## HISTORIC AND DESIGN REVIEW COMMISSION

**HDRC CASE NO:** 2017-072  
**ADDRESS:** 504 KING WILLIAM  
**LEGAL DESCRIPTION:** NCB 749 BLK 8 LOT 9,10, NW IRR 28.2FT OF 1 & NW 61.2 FT OF 2  
**ZONING:** RM-4, H HS RIO 4  
**CITY COUNCIL DIST.:** 1  
**DISTRICT:** King William Historic District  
**LANDMARK:** Steves, Albert - House  
**APPLICANT:** Jim Poteer/Poteet Architects, LP  
**OWNER:** Laurel Heights Family Irrevocable Trust  
**TYPE OF WORK:** Construction of a rear accessory structure  
**REQUEST:**

The applicant is requesting a Certificate of Appropriateness for approval to construct a rear accessory structure at 504 King William to front E Johnson Street, on the east side of the property.

**SITE PLAN:** PROPOSED  
SCALE: 1" = 25'-0"

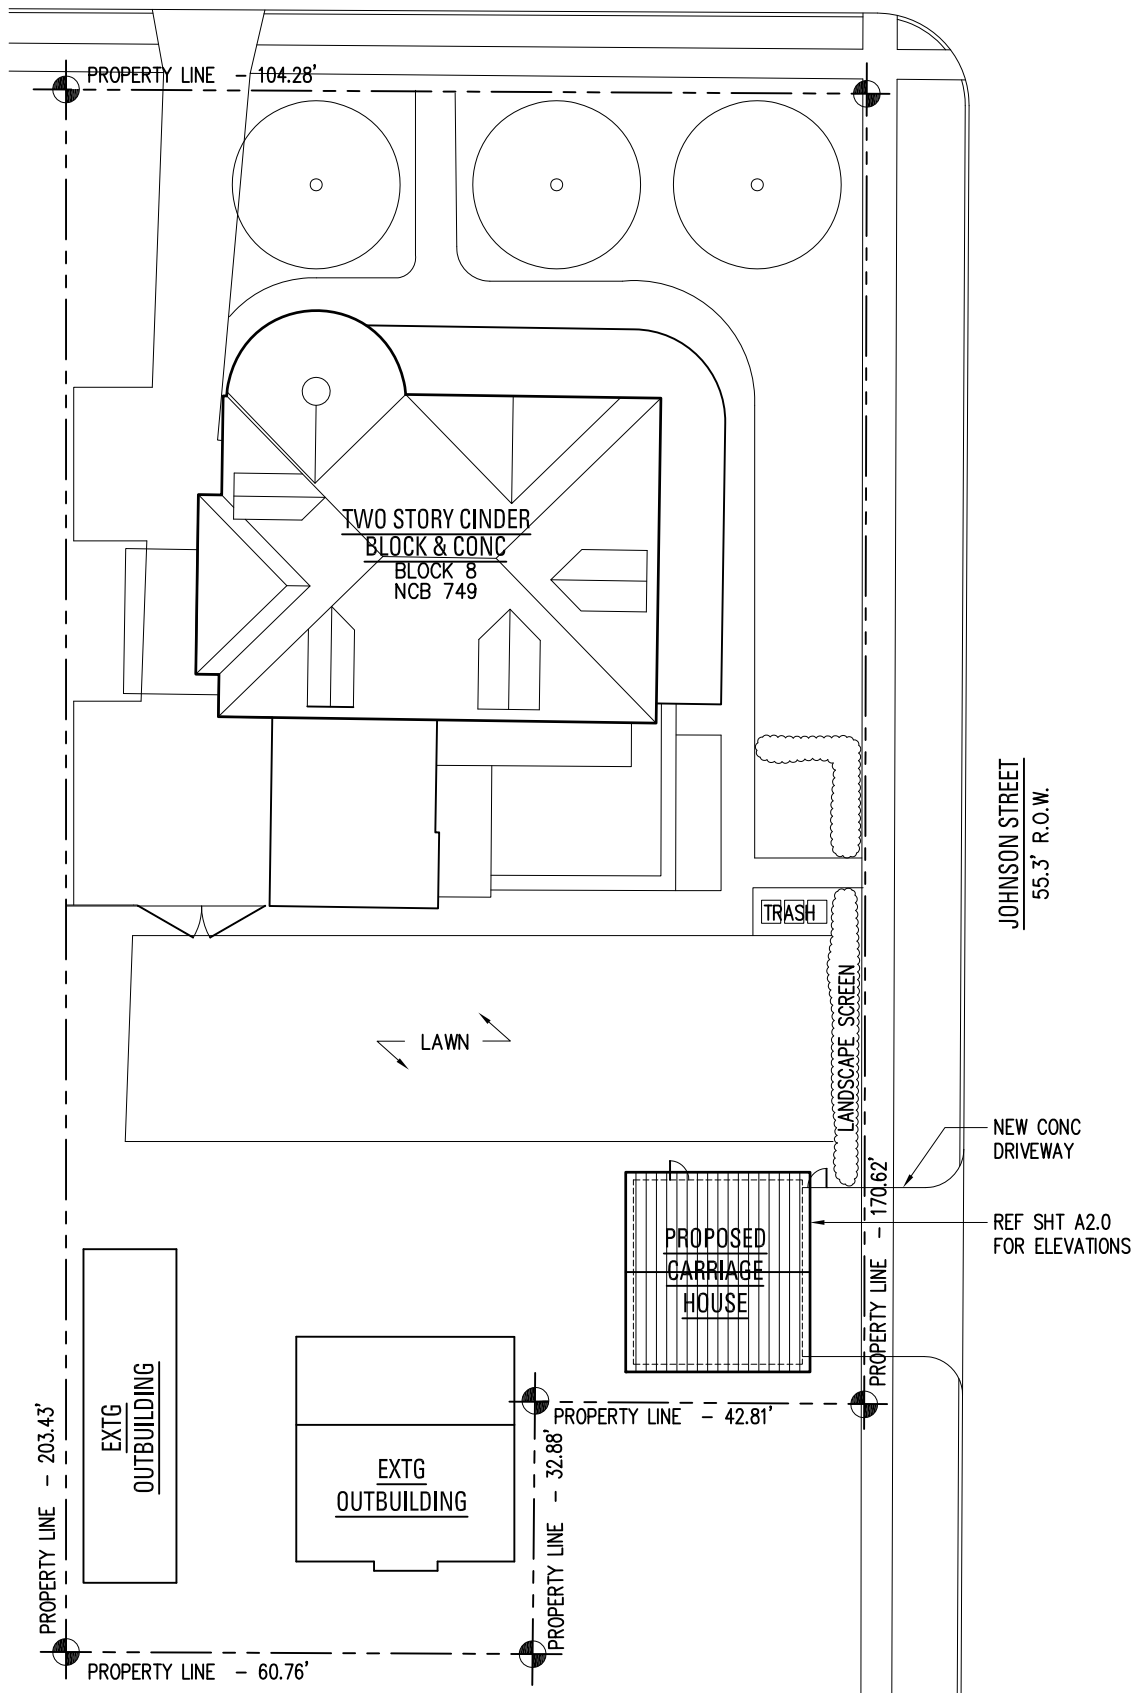
- e. **SETBACKS** – The applicant has proposed a setback of five (5) feet from the rear property line and 8’ – 1” from the public right of way along E Johnson. This setback is generally consistent with the setbacks of other structures along E Johnson.

- f. **DRIVEWAY** – The applicant has proposed for the accessory structure to feature access for two vehicles and has proposed to install a curb cut and concrete driveway to feature an overall width of approximately 21’ – 0”. The Guidelines for Site Elements 5.B. notes that new driveways should feature similar proportions to those found historically throughout the district. Historically, driveways in the King William Historic District feature a width of no more than ten (10) feet. Staff finds the installation of a new curb cut and driveway on E Johnson appropriate; however, staff finds that the applicant should install a landscaping element centered on the proposed garage to extend to the sidewalk at the public right of way to split the proposed driveway into two separate driveways. Staff finds that the installation of two ribbon strip driveways would also be appropriate. While this width is not typical in historic districts, there is an established pattern along E Johnson for additional driveway width.

- i. That the applicant install a landscaping element centered on the proposed garage to extend to the sidewalk at the public right of way to split the proposed driveway into two separate driveways.

504 KING WILLIAM	<b>A2.0</b> SHT 5 OF 5
DATE: FEBRUARY 10, 2017	
POTEET ARCHITECTS, LP

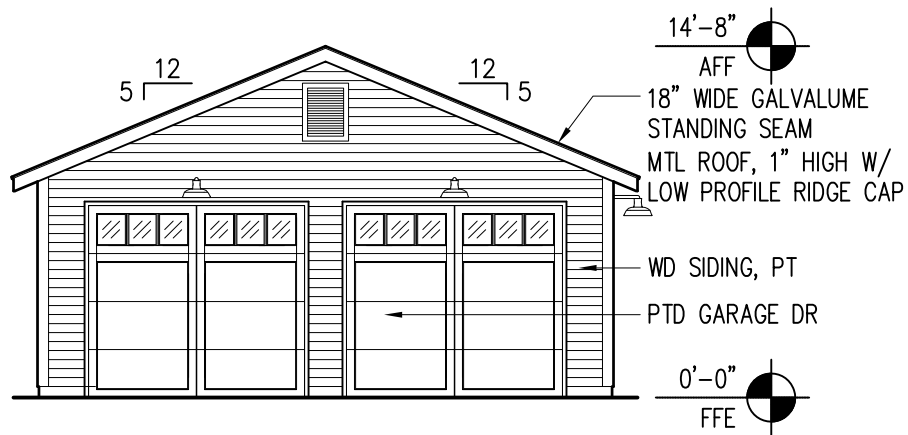
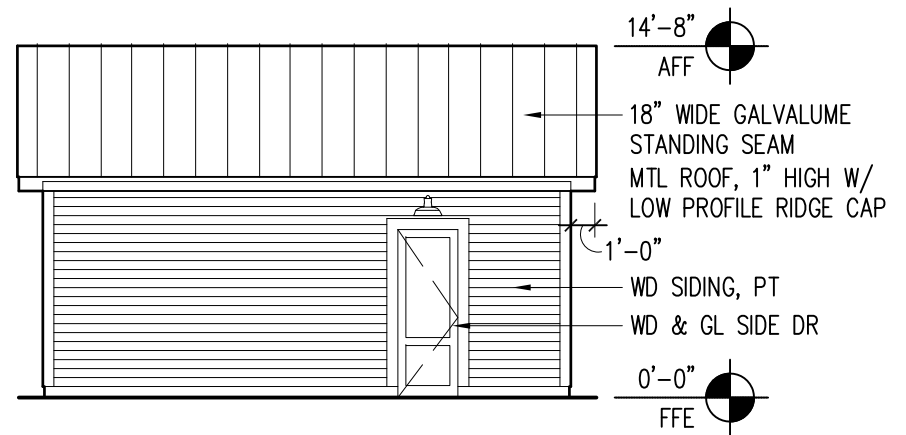
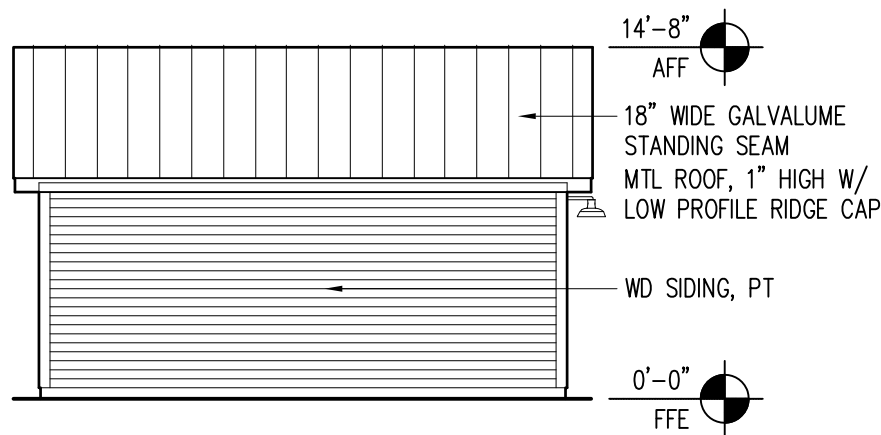
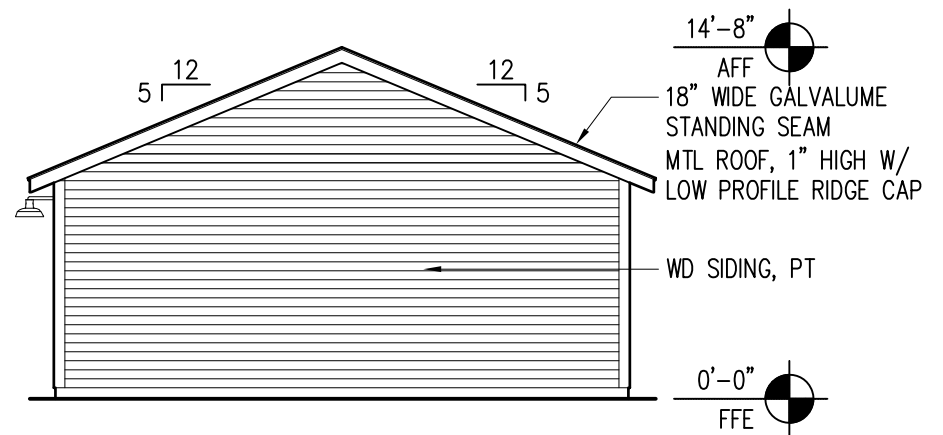
- b. **MASSING & FORM** – The applicant has proposed to construct a rear accessory structure at the eastern corner of the property to front E Johnson Street. Per the Guidelines for New Construction 5.A.i., new garages and outbuildings should be visually subordinate to the principal historic structure in terms of their height, massing and form. Additionally, new outbuildings should be no larger than forty (40) percent in plan of the primary historic structure’s footprint. The applicant has proposed an overall footprint of approximately 485 square feet and an overall height of approximately fifteen (15) feet. The proposed accessory structure is subordinate to both the primary historic structure and the two historic accessory structures on the lot. Staff finds this appropriate and consistent with the Guidelines.

- c. **CHARACTER & MATERIALS** – The applicant has proposed materials to include wood siding, wood carriage door, a wood pedestrian door and a standing seam metal roof. The proposed standing seam metal roof is to feature specifications that are consistent with those outlined in the Guidelines for Exterior Maintenance and Alterations. The proposed materials are consistent with the Guidelines.
